THE NATIONAL BOARD
OF BOILER AND PRESSURE VESSEL INSPECTORS

NATIONAL BOARD INSPECTION CODE SUBCOMMITTEE INSTALLATION

MINUTES

Meeting of July 17, 2024
Louisville, KY

FIGURE 3.7.5.1-c
 HOT-WATER BOILERS IN BATTERY — ACCEPTABLE PIPING INSTALLATION

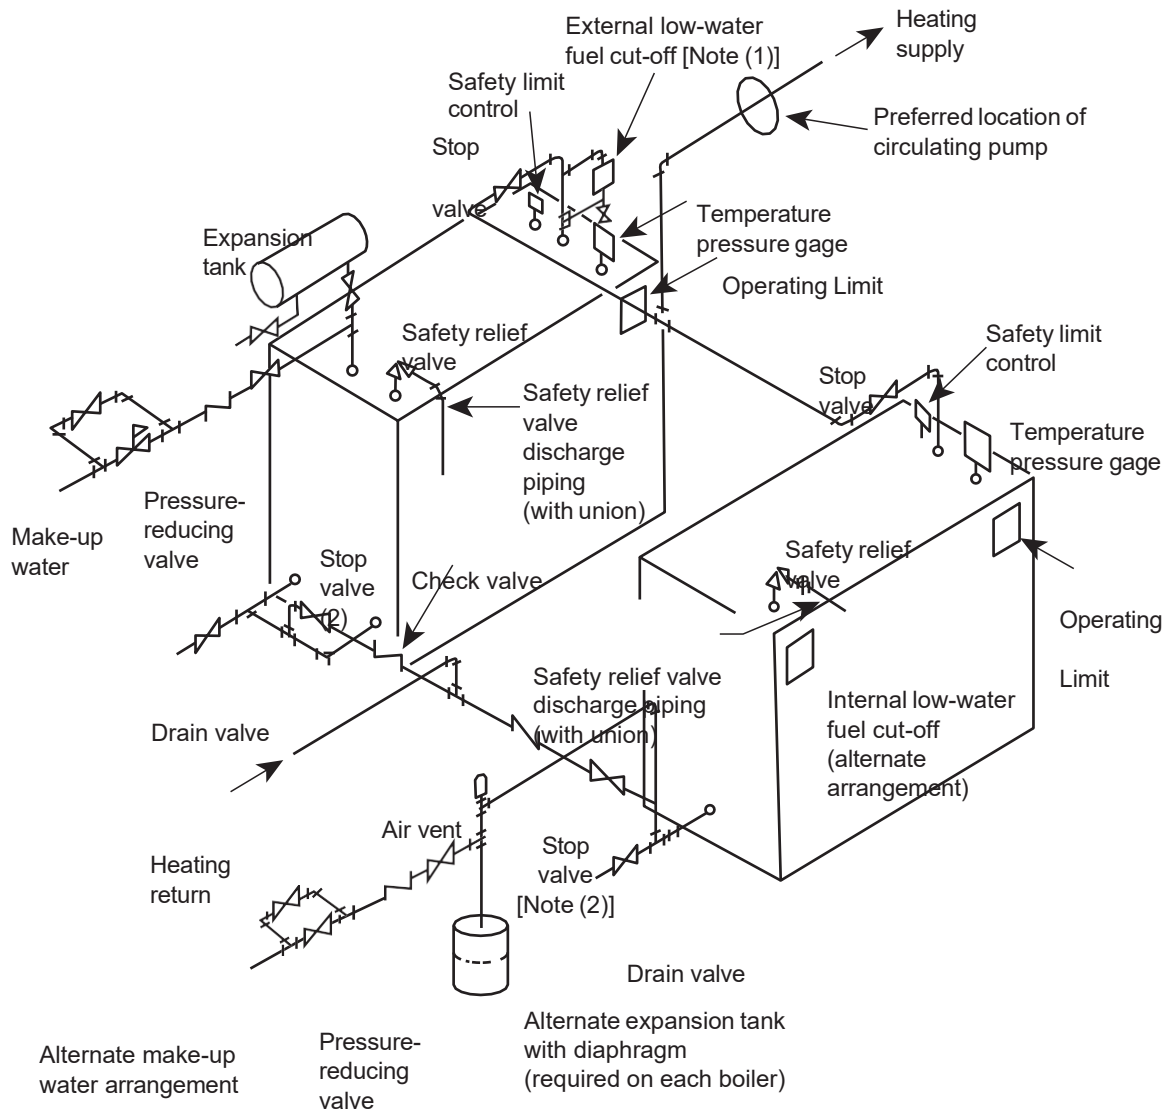
Item Number: 24-30	NBIC Location: Part 1, Figure 3.7.5.1-c	Attachment Pages 6-8
<p>General Description: Revise Note 1 in Part 1, Figure 3.7.5.1-c for clarity</p> <p>Subgroup: SG Installation</p> <p>Task Group: R. Adams (PM)</p> <p>Explanation of Need: This is being submitted on Gary Scribner's behalf: Please review and revise to clarify what Note 1 is trying to communicate. Consider rewriting the third sentence to be more specific.</p>		
<p>July 2024 Meeting Action: Proposal</p> <p>Mr. Adams reviewed the actions from subgroup. After the committee made a minor editorial change, a motion was made to accept the proposal as revised. The motion was seconded and unanimously approved.</p>

Explanation of Need: Please review and revise to clarify what Note 1 is trying to communicate. Consider rewriting the third sentence to be more specific.

(1) Recommended control. See [3.8.2.4 d](#) - *ASME Section IV, HG-614*. ~~Acceptable shutoff valve or cocks in the connecting piping may be installed for convenience or control testing and/or service.~~

FIGURE S3.6.1-a

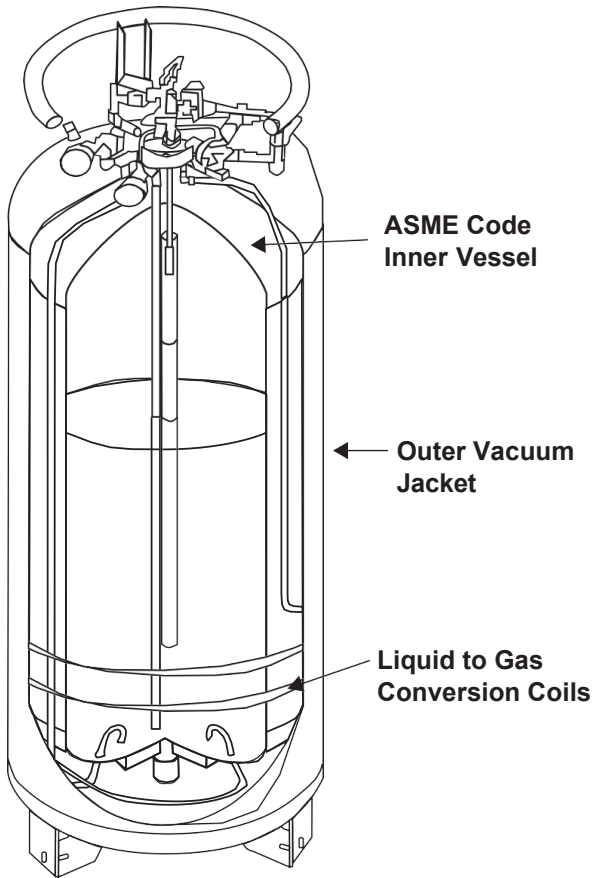
Item Number: 24-56	NBIC Location: Part 1, S3.6.1	Attachment Pages 11-13
<p>General Description: LCDSV Systems: Add Table and Figure</p> <p>Subgroup: SG Installation</p> <p>Task Group: M. Byrum (PM), R. Black</p> <p>Explanation of Need: In accordance with the NBIC Policy For Metrication, metric units need to be shown alongside US customary units. Table S3.6.1 and Figure S3.6.1-b both show only US customary units. I recommend adding a Table S3.6.1M and Figure S3.6.1-bM to show metric units. I've also included some additional editorial recommendations.</p>		
<p>July 2024 Meeting Action: Proposal</p> <p>Mr. Byrum summarized the proposal and changes made at the subgroup meeting. A motion was made to accept the proposal as presented. The motion was seconded and unanimously approved.</p>

FIGURE S3.6.1-b
CO₂ PHASE DIAGRAM

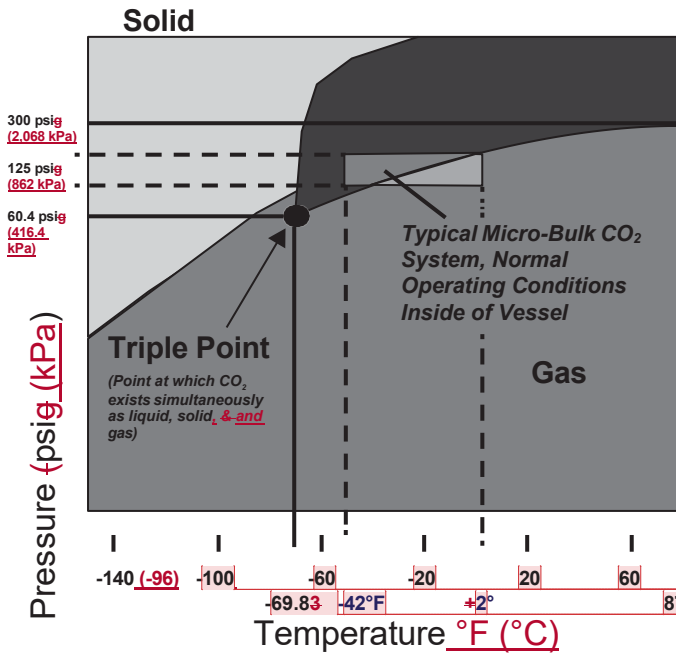
See ~~the attached Figure S3.6.1-b for a CO₂ phase diagram CO₂ Phase Diagram NBIC Part 1; Figure S3.6.1-b,~~ showing the typical operating range of these systems. Components external to the LCDSV inner tank pressure vessel may encounter pressures and temperatures between 90 psig, and -56°F, to 300 psig and +2°F, respectively {between 620 kPa, and -49°C, to 2,068 kPa and -16°C, respectively}. Typical operating pressures and temperatures vary in each of the associated sub-system circuits. (See NBIC Part 1, Table S3.6.1.)

Commented [MV1]: Note: the comments below are the equivalent Celsius temperatures to add next to or below the Fahrenheit temps

- Commented [MV2]: Add -(73) to this
- Commented [MV3]: -51
- Commented [MV4]: -29
- Commented [MV5]: -7
- Commented [MV6]: 16
- Commented [MV7]: 56.6
- Commented [MV8]: -41
- Commented [MV9]: 7
- Commented [MV10]: 30
